**RE: MP09\_0187 MOD 2 – AMENDED PLANS**  
**PROPERTY: NOS. 6-16 ATCHISON STREET, ST LEONARDS**

I am writing with regard to the above Section 75W Application, the Department's email correspondence dated 8 November 2013 and the meeting with the Department on 15 November 2013. The items raised by the Department are addressed below.

**Figure 1:** Indicative Site Overlay Plan which demonstrates the extent of the site which is required to be open at ground level to satisfy the minimum overhead clearance of 4500mm (AS 2890.2 2002) (area highlighted in green).

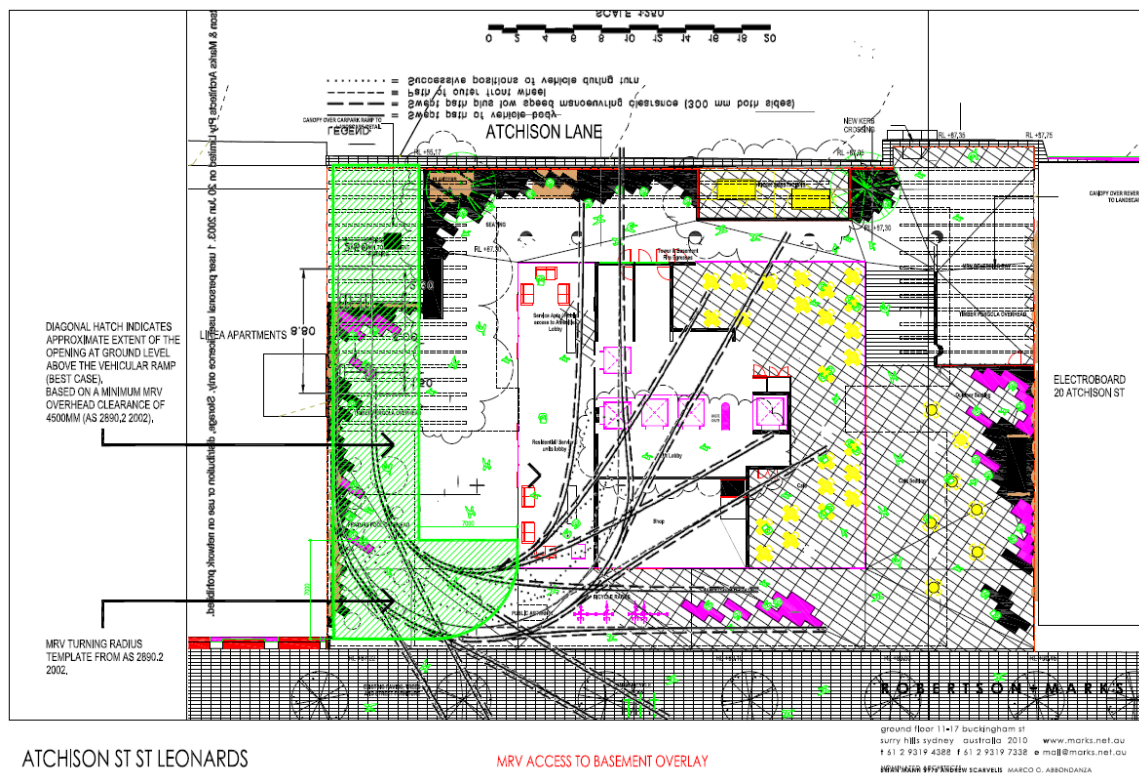
Given these site constraints and through further detailed architectural design it has become apparent that the capacity for the site to accommodate medium rigid vehicles (MRVs) within the basement parking levels would require a large proportion of the public domain area to be removed to achieve the clearance heights as required by the Australian Standards. **Figures 1 and 2** below demonstrate the area of the public domain area which would be removed to accommodate a MRV, being a minimum area of 230m<sup>2</sup>. Furthermore, the basement levels would be required to be lowered by 300mm-500mm.

Furthermore, this revised design would require a longer and shallower ramp grade, therefore requiring the circulation area of Basement Level 1 to be revised. As demonstrated in **Figures 1 and 2** above, significant circulation space would also be required for the MRV to manoeuvre within the site to successfully exit by the ramp, as well as additional excavation to satisfy the clearance heights.

Given the site constraints above, it is not considered desirable or reasonable to redesign the basement to accommodate a MRV given the public domain level to Atchison Street would be significantly reduced / interrupted, and the poor circulation which would be required for vehicular ingress and egress. Also refer to further justification in the section entitled 'Garbage Storage' below.

It is therefore proposed to retain the design of the basement as per the plans recently submitted to the Department, as this provides a functional vehicular arrangement. That is, SRV access to the basement and MRV access via a loading bay on the eastern side of the site. From **Figure 2**, it can be seen that the MRV will not be highly visible from either Atchison Lane or the public domain areas when deliveries are being made or garbage collection occurring. Noting the garbage collection will be done within the ramp and thus not visible from the lane, this solution is considered more desirable.

**Figure 4:** Approved Site Plan (MP09\_0187) which demonstrates the public domain treatment to Atchison Lane comprises planters, balustrades, steps and a narrow pathway area at the eastern side of the site.

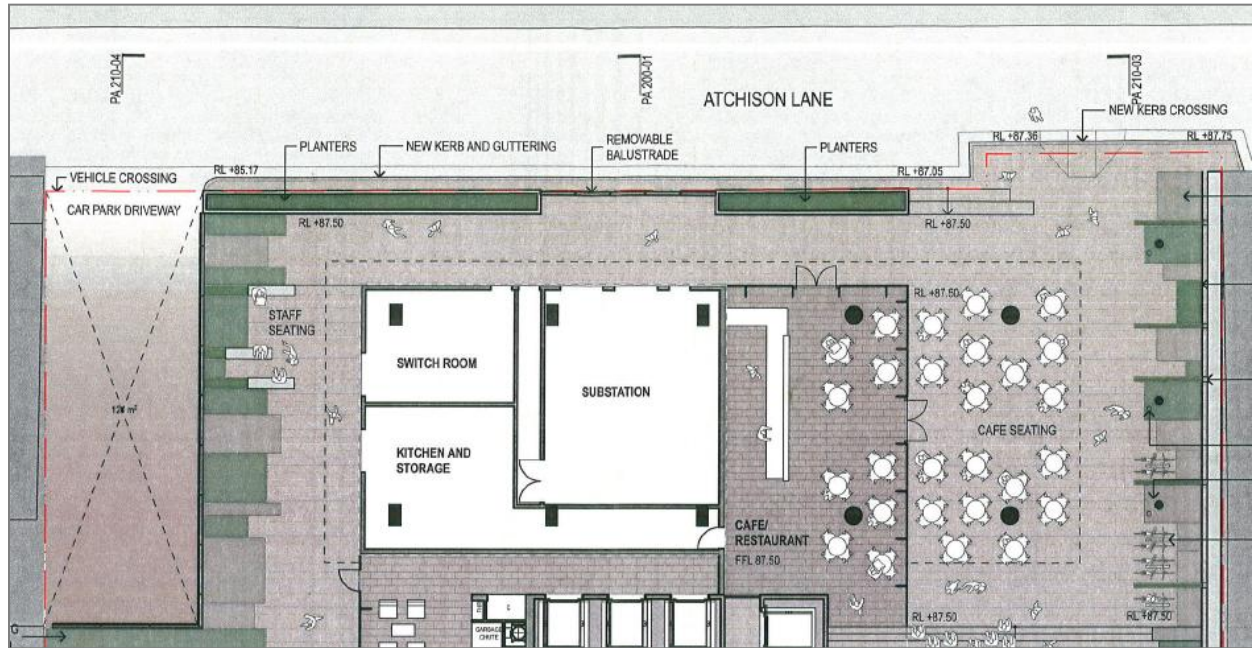
The Department has requested that the configuration of the Atchison Lane frontage is maintained as approved. As demonstrated in **Figure 4** below, the approved scheme comprises a dedicated car park driveway area, uniform planter boxes, steps and a narrow pathway at the eastern side of the site. Through the recent design and development of the current scheme, it is considered that functionality and presentation of the rear portion of the site can be improved to provide a more unique presentation.

As shown in **Figure 5** below, the proposed scheme maintains the pedestrian paths of travel throughout the site and provides a direct and pleasant environment and through-site link. The configuration of the rear through-site link offers a high degree of functionality, with the necessary services being located and arranged in an efficient manner which satisfies the relevant requirements. The proposed public domain plane creates areas of retail use and passive recreational areas which complement the use of the site and its functionality.
